REVISED RESPONSE TO REQUEST FOR ADDITIONAL INFORMATION**APR1400 Design Certification****Korea Electric Power Corporation / Korea Hydro & Nuclear Power Co., LTD****Docket No. 52-046**

RAI No.: 399-8510

SRP Section: 15.06.05 – Loss of Coolant Accidents Resulting From Spectrum of Postulated Piping Breaks Within the Reactor Coolant Pressure Boundary

Question No. 15.06.05-7

Figure 1. Reactivity vs. Moderator Density for LOCA Evaluation

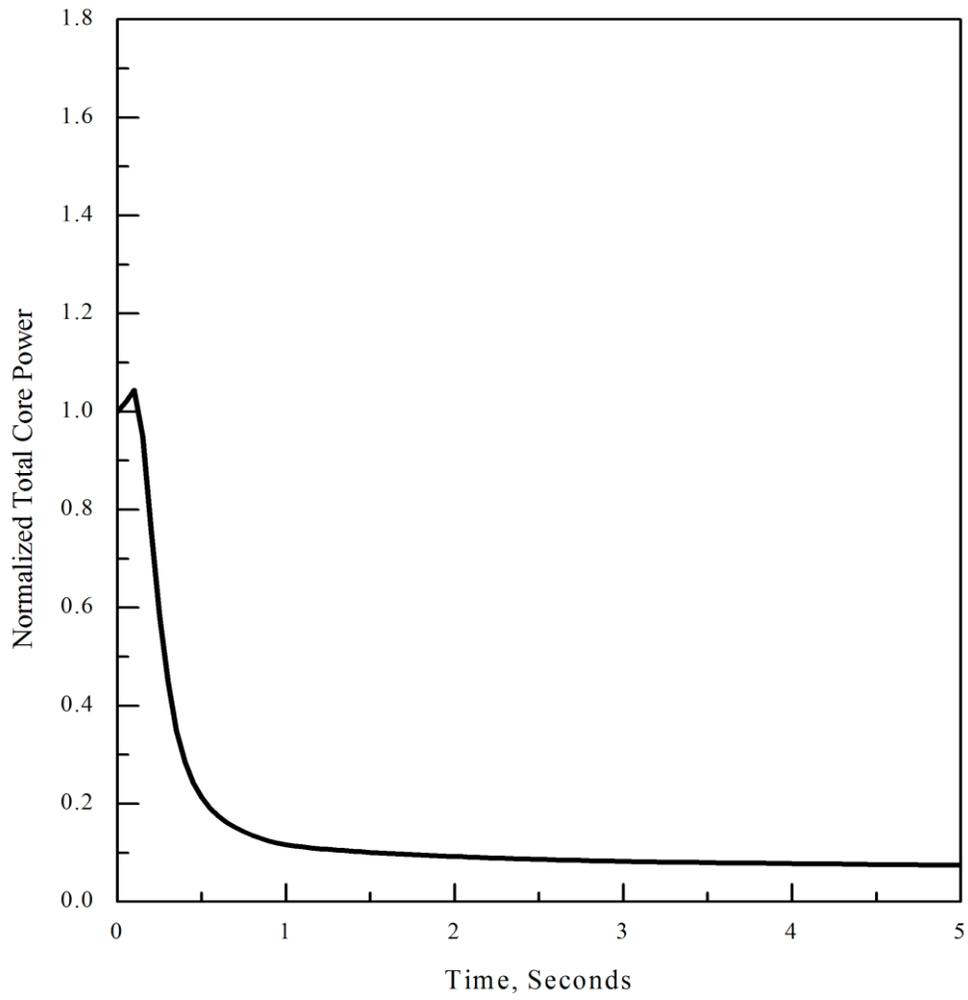
1. A verification and an explanation for the shape and magnitude (positive reactivity at some densities) of the curve. In particular, the increase in reactivity with decreasing moderator density for densities above 500 kg/m³.
2. A justification for the use of the conservative curve in a best estimate plus uncertainty evaluation.
3. An explanation for the rapid increase in reactor power during the first 0.5 sec of the LBLOCA transient, and
4. An evaluation of fuel performance during this spike in power to determine if the fuel fails due to PCMI or fuel melt.

Figure 1 shows a curve of reactivity vs. moderator density used in the LOCA evaluation. The value of the density coefficient used corresponds to a 0 MTC for the small break events and $+0.5 \times 10^{-4} \Delta\rho/^\circ\text{F}$ for the large breaks (Table 4.3-3 of the APR1400 DCD).

As moderator temperature increases or pressure decreases, the moderator density decreases reducing the amount of moderator in the core. Decreasing moderation leads MTC to become more negative. But the amount of soluble boron is also reduced when the moderator density decreases. Reducing neutron absorption of boron leads to a positive effect on reactivity.

The higher boron in the MDC curve corresponding to $+0.5 \times 10^{-4} \Delta\rho/^\circ\text{F}$ MTC causes positive reactivity with decreasing moderator density compared with a MDC curve corresponding to 0 MTC.
